## SYDNEY NORTH PLANNING PANEL COUNCIL ASSESSMENT REPORT

<b>Panel Reference</b>	PPSSNH-342
<b>DA Number</b>	DA2022/1510
<b>LGA</b>	Northern Beaches
<b>Proposed Development</b>	Demolition works and Construction of a mixed use development to accommodate a café, church, conference centre, boarding house and two level of basement car park.
<b>Street Address</b>	Part Lot 28 DP 7413, 9 Francis Street DEE WHY NSW 2099 Part Lot 28 DP 7413, 28 Fisher Road DEE WHY NSW 2099 Part Lot 28 DP 7413, 28 Fisher Road DEE WHY NSW 2099
<b>Applicant/Owner</b>	The George Group Pty Ltd Baptist Churches of NSW Property Trust
<b>Date of DA lodgement</b>	28/09/2022
<b>Number of Submissions</b>	19
<b>Recommendation</b>	Approval
<b>Regional Development Criteria (Schedule 7 of the SEPP (State and Regional Development) 2011)</b>	State Environmental Planning Policy (Planning Systems) 2021, Schedule 6 (5) Private infrastructure and community facilities over \$5 million
<b>List of all relevant s4.15(1) (a) matters</b>	<ul style="list-style-type: none"> <li>• Environmental Planning and Assessment Act 1979</li> <li>• Environmental Planning and Assessment Regulation 2021</li> <li>• State Environmental Planning Policy

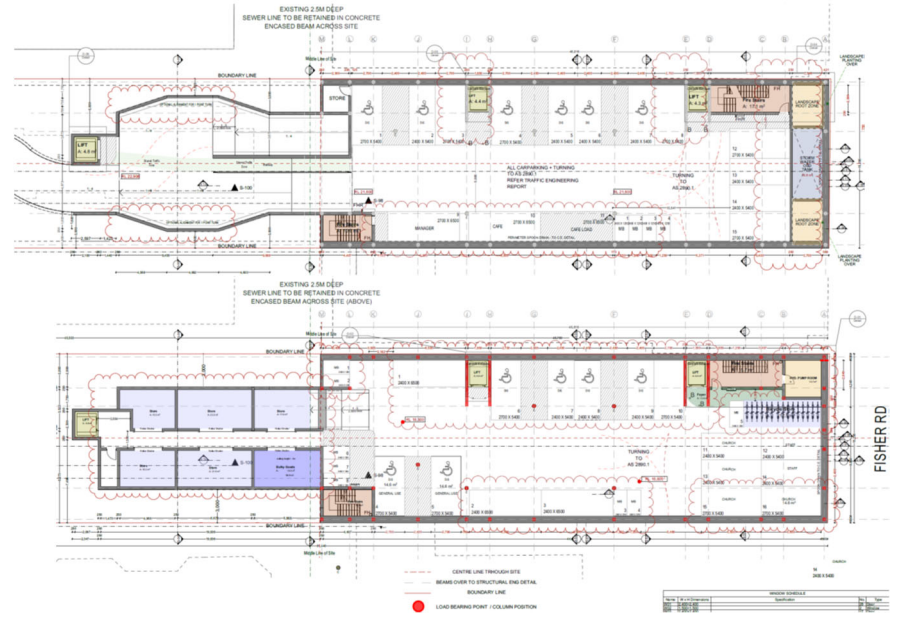
2 levels of car parking are proposed for church goers and boarding house residents. A high proportion of disabled parking is provided to meet the needs of the residents with tandem car spaces for church goers and some bicycle parking. As noted previously it is the Panels view that priority should be given to the needs of the residents.

No columns are shown on the plans which make it difficult to assess whether manoeuvrability is possible and convenient through the basement levels and access driveway approach which splits to the 2 levels. 3-point turns are shown at the end of the basement driveways but it's unlikely that disabled drivers would be able to negotiate this. Additionally, it would appear that there is no side setback for spaces 16, 17, 18 and part of space 1.

Tandem parking for church goers is awkward; tandem parking is usually provided for co-habitants in the same unit in residential developments.

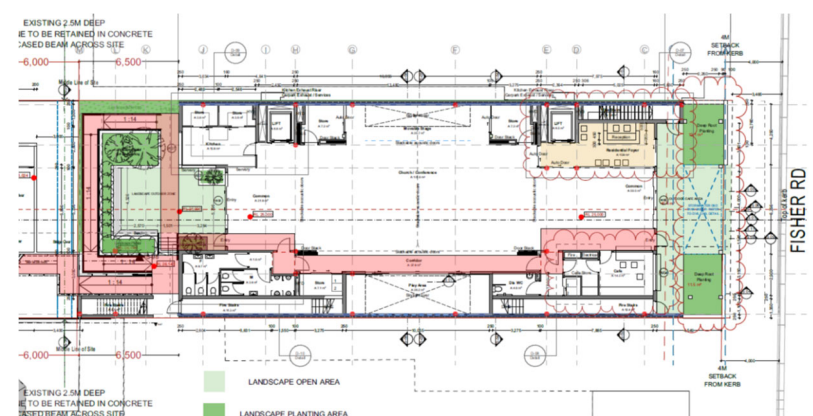
The Panel found the design very difficult to understand. What purpose does the 1:14 ramp for the "Common Outdoor Zone" perform? How is the hydrotherapy pool accessed? Why is it next to the managers private open space?

The alternative access to the Church from Francis Street is awkward and undesirable and this space is best and most appropriately dedicated for residents only.

- Single car driveway vehicle ramp down noted as supported. Permeable landscape at sides of driveway waiting area at the frontage has been incorporated onto the landscaping plan to diminish the required 2-car waiting space at the head of the ramp off Francis St.

- The design has been simplified in relation to access through the outdoor spaces and the Common Zone has been raised to Level 1 (from basement ground level).

**Recommendations response for car movement and parking**

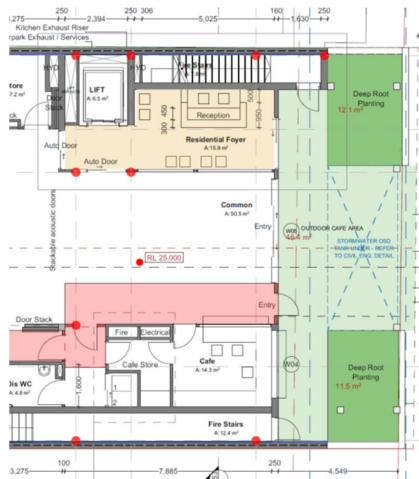
6. Allow the basement to encroach into the 2.500m setback to provide 'optimal alignment for 1 point turn'
7. Remove tandem parking

1. Traffic and Carparking has previously achieved Council endorsement, but the planning has been further eased after current amendment. A wider U-turn facility and eased parking arrangements (less carparking means more width etc) are features of this amendment. This U-turn head requires relaxation of the setback requirements to 1.5m at basement only on Francis St side. There is deep soil landscape over. Australian Standard widths have been widened adjacent to structural obstruction elements. Total carparking numbers have been lessened to 31 total (but still greater than the required 29).

2. A wider and longer area has been arranged for car manoeuvring and U-turn facility at the mid landing point at the head of lower ramps for better sight lines. A designated pedestrian path to the lift has been assigned. This will work with the traffic management system.

PROPOSED PEDESTRIAN ENTRY FROM GROUND LEVEL (yellow) WITH SEPARATE FOYER TO LIFT ACCESS

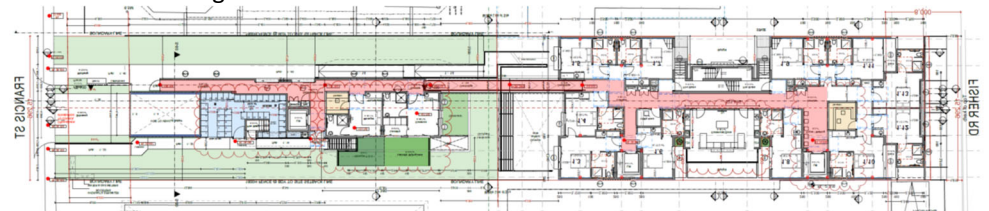
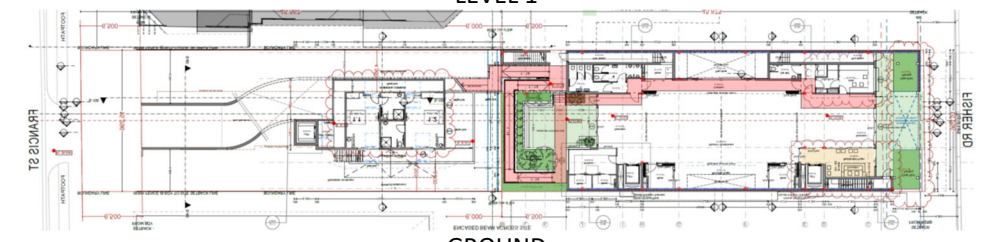
Separate residential access from Fisher Road for the residences would be positive from a usability, safety, social and streetscape point of view. It says a lot about respect to residents about where and how the entry occurs and this should be an important consideration. This could also allow the circulation through the rear of the site to the benefit of the amenity of the landscape.

8. A new pedestrian entry for the residential rooms has been designed at the ground level Fisher Rd frontage.

9. The circulation has been redesigned, with a clear, internal focus at level 1 for residential pedestrian access through the site that demonstrates service and control mechanisms at the entries for the public

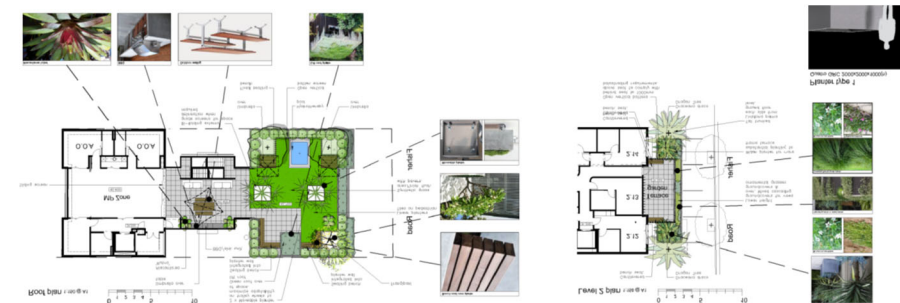
The Fisher Street frontage treatment is limited by the basement under and building extending over. This is to the detriment of the café tenancy and the streetscape. It is unlikely that trees will be possible in the narrow verge which is impacted by the overhead power lines.

The Francis Street setback is significantly impacted by the driveway. The paved area is wider than the basement entry and this reduces the potential for landscaping and improving the character of this frontage to the street.

The lowered, narrow, and overshadowed nature of the landscape spaces are going to be difficult to develop as usable, high amenity spaces. While the landscape offers a lot of vegetation, which is positive, it is also exacerbating the deep, shaded, dark nature of these areas.

**Landscape Response**

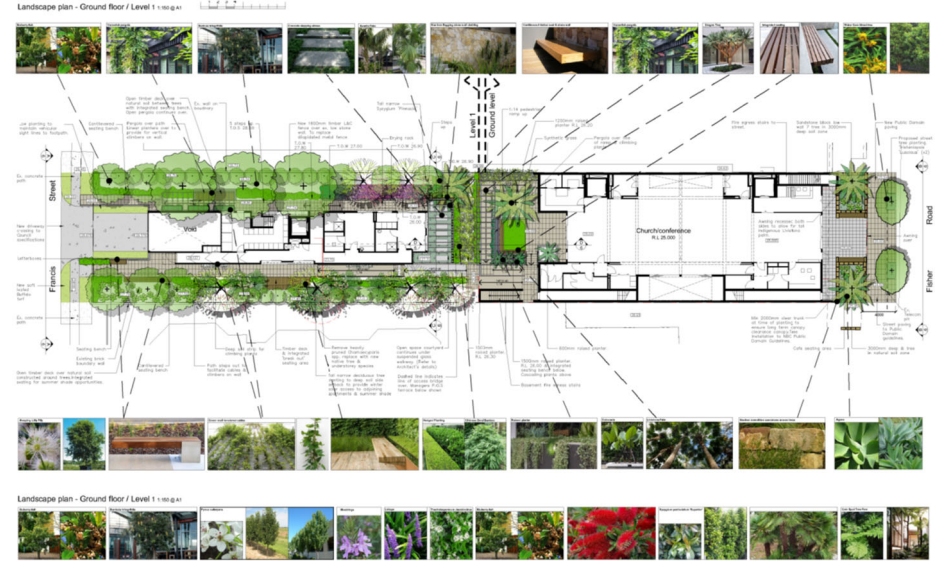
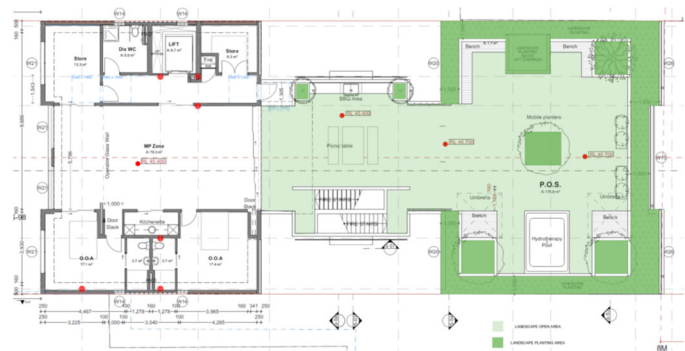
The rooftop open space is a very positive provision and will offer a sunny usable area. While the water tanks are supported, they are taking up valuable rooftop space.

- We note that after amendment the project has achieved a preliminary endorsement for the council referral.
- It is acknowledged that the site is a challenging shape and proportion and we have tried to get the best from the available space. We have engaged with specialist landscape architects and urban designers to achieve this.

- The presentation and entry experience have been eased in relation to DSAP comments.
- Communal spaces that were in a semi-basement zone have been relocated to a more open and central location on the rear of the Francis St site. The hydrotherapy pool has been relocated to the communal roof space at the Fisher Rd site.

- Landscaping has received attention to open it up whilst maintaining privacy aspects. Deciduous trees will provide winter sun entry to long narrow spaces. Council LEP calls for minimum dimensions of space that informs the site development zones. The articulated building form and significantly lower Francis St roof than height allowance will allow for sun entry and achieves side boundary envelopes at Francis St site.

- Water tanks have been diminished in size and width with planting to their tops.
